**LEGAL ADVERTISEMENT
PORTLAND PLANNING BOARD MEETING**

- i. **Tabled on 10/12/16 to 10/25/16.** Level III Site Plan; 7 Unit Residential Building; 30 Merrill Street; Banner Properties, LLC., Applicant. (7:00 – 8:00 p.m. estimated time). The Board will hold a public hearing on a proposal for a new seven-unit residential building. The existing two family building will be replaced with a four story 6,580 sq. ft. building with 7 condominiums. Parking for 6 vehicles is proposed behind the building. The site is in the R-6 zone.

AGENDA PORTLAND PLANNING BOARD MEETING

- i. **Tabled on 10/12/16 to 10/25/16. Level III Site Plan; 7 Unit Residential Building; 30 Merrill Street; Banner Properties, LLC., Applicant.** (7:00 – 8:00 p.m. – estimated time) The Board will hold a public hearing on a proposal for a new seven-unit residential building. The existing two family building will be replaced with a four story 6,580 sq. ft. building with 7 condominiums. Parking for 6 vehicles is proposed behind the building. The site is in the R-6 zone.

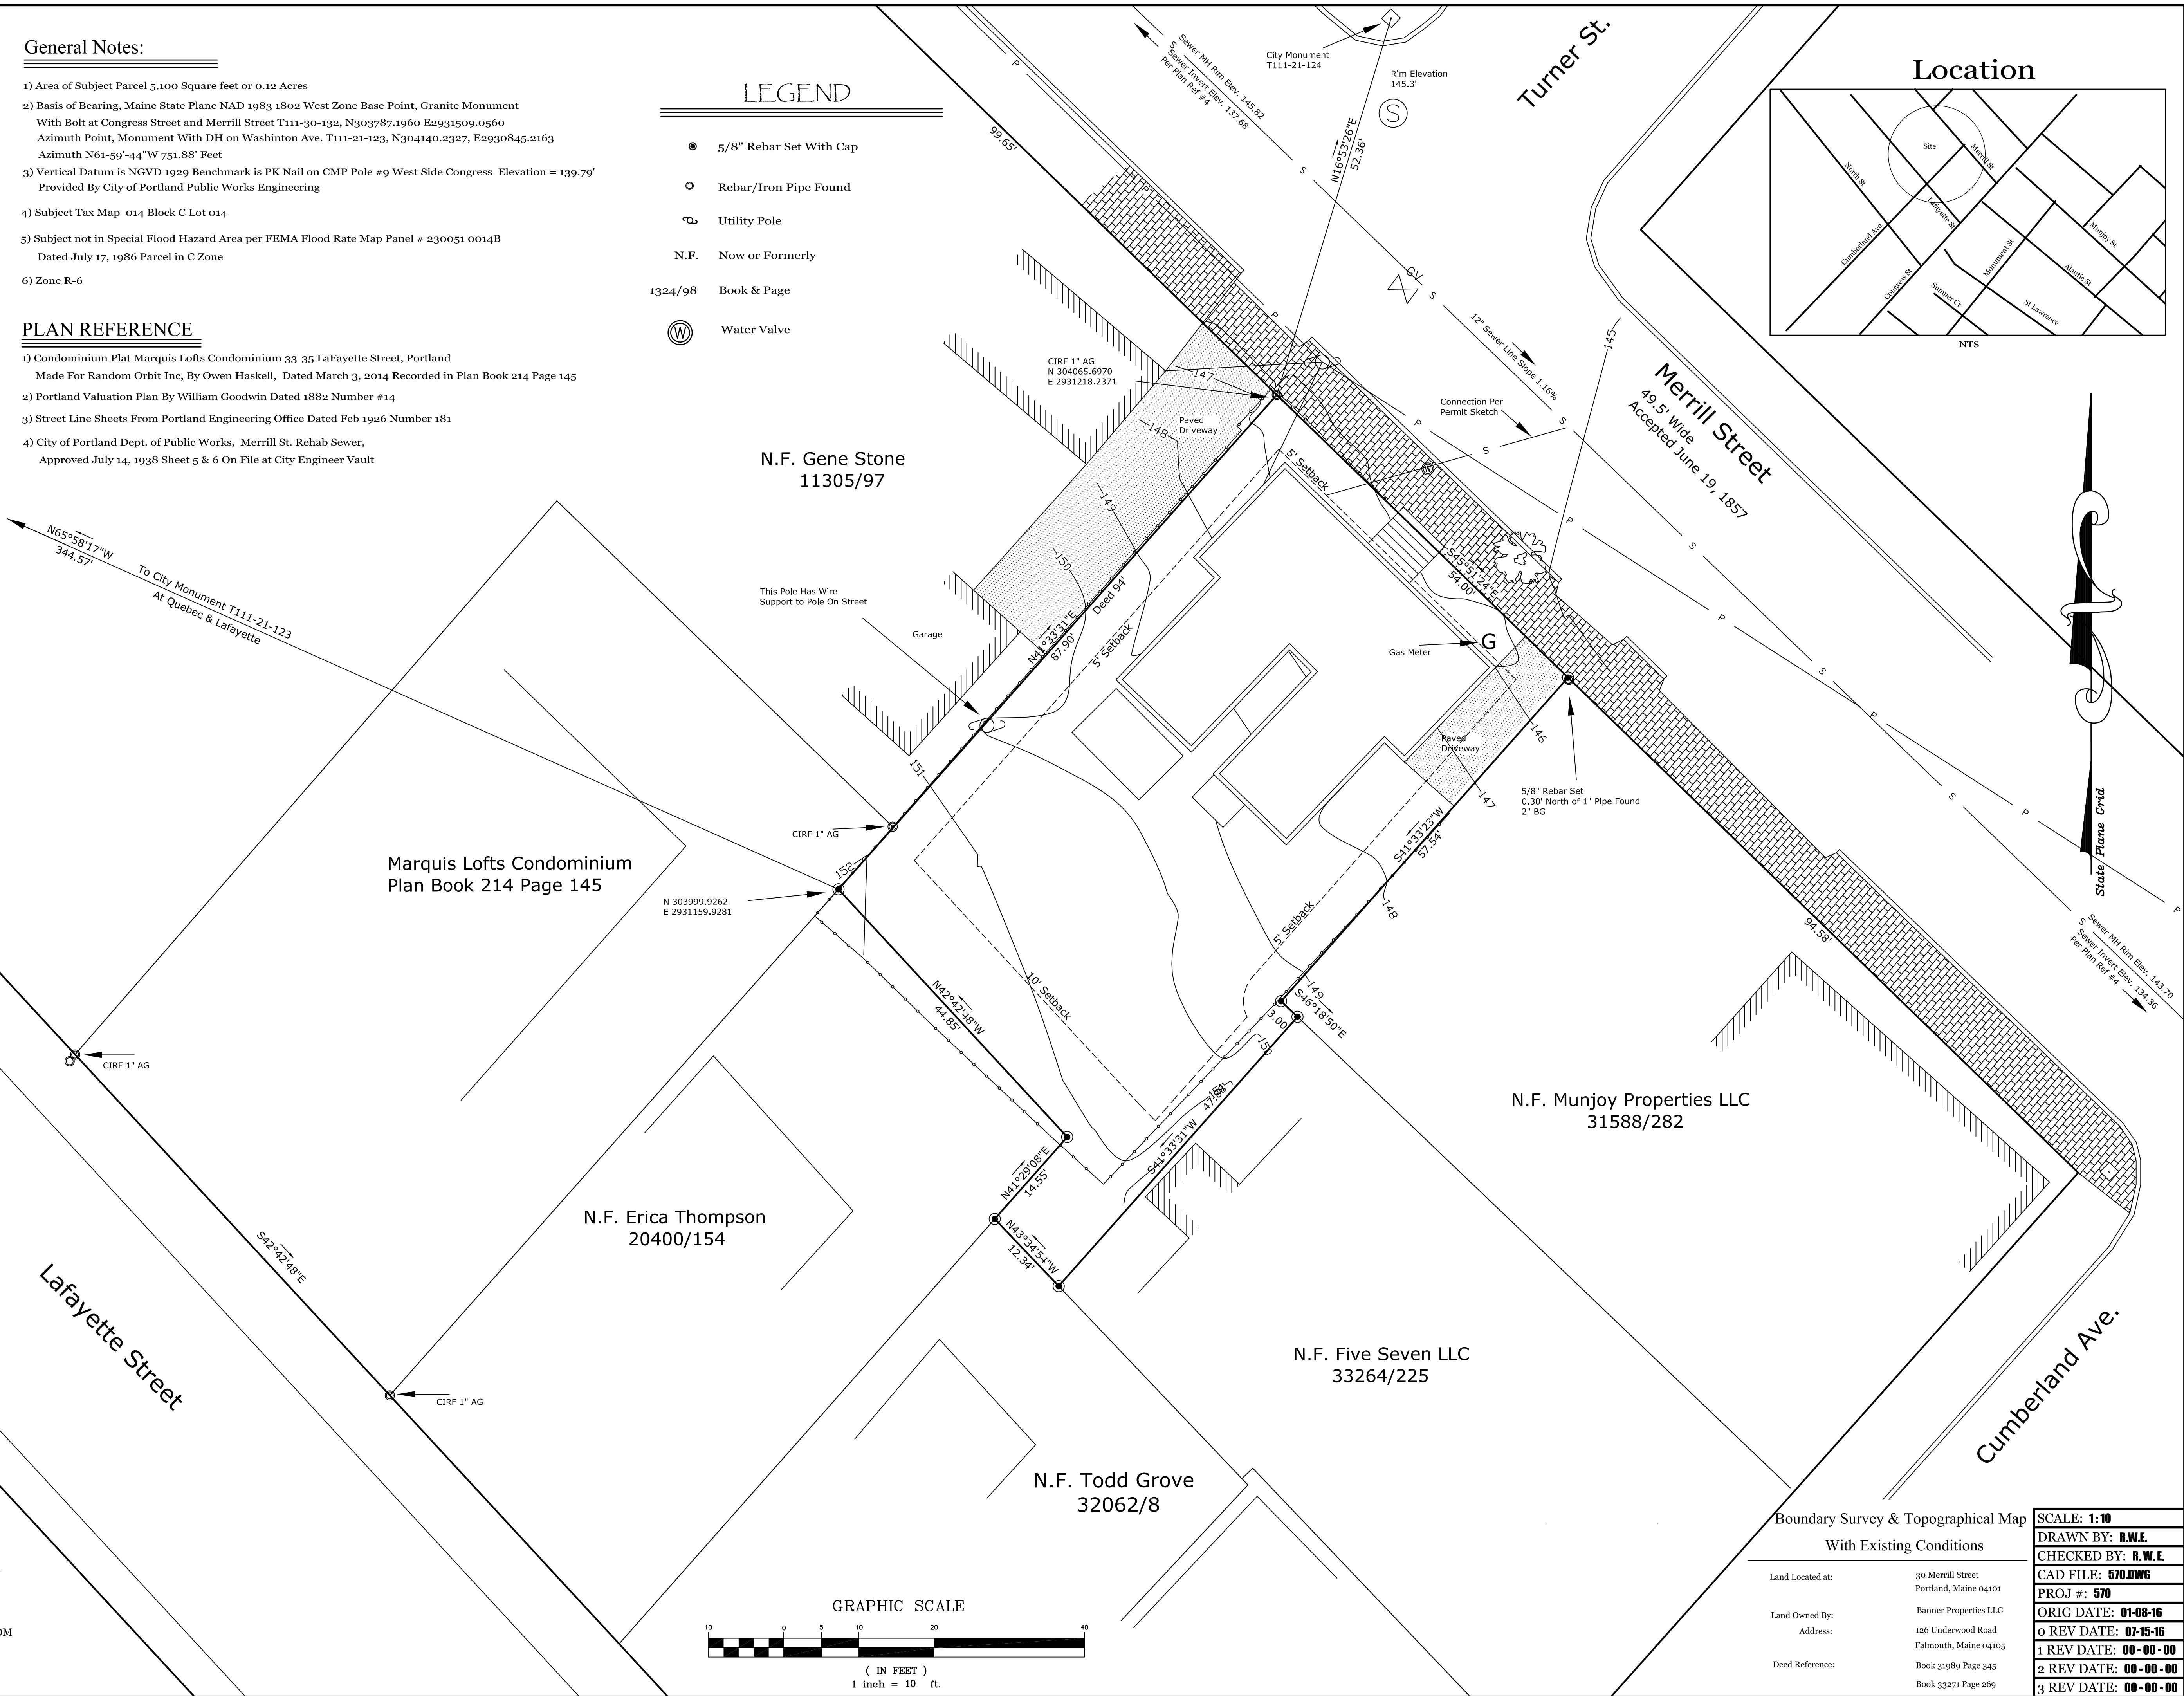
- *The Pervious Paver Section Detail provided on Sheet C2 includes a Filter Layer; however, the Site Plan and stormwater management plan indicate that the limit of the proposed filter bed does not extend over the full area of proposed pervious pavers. A detail should be provided for paver installation in areas outside of the filter bed, to confirm that the entire paver area may be considered pervious. If the additional pavers are not installed in such a way that they are pervious, the impervious surface calculations should be updated, and the filter area should be designed per the Maine DEP Stormwater BMP manual's guidance for "Run-On Modular Pervious Pavement."*

- Addition of a Landscape List on Sheet C1,
- Removal of the parking space closest to the building, adjacent to the Handicap space,
- Moved Handicap closer to building to increase access to snow storage area in the rear,
- Addition of an alternate style of pavers next to the building to indicate a pedestrian walking area,
- Addition of a 4'x4' concrete pad at the door adjacent to the parking lot,
- Note to center and renovate the brick driveway entrance and granite curbing for the site, and
- Note on the Pervious Paver Detail (Sheet C4) to indicate a potential need for an impervious liner if separation from bedrock cannot be achieved on the site,
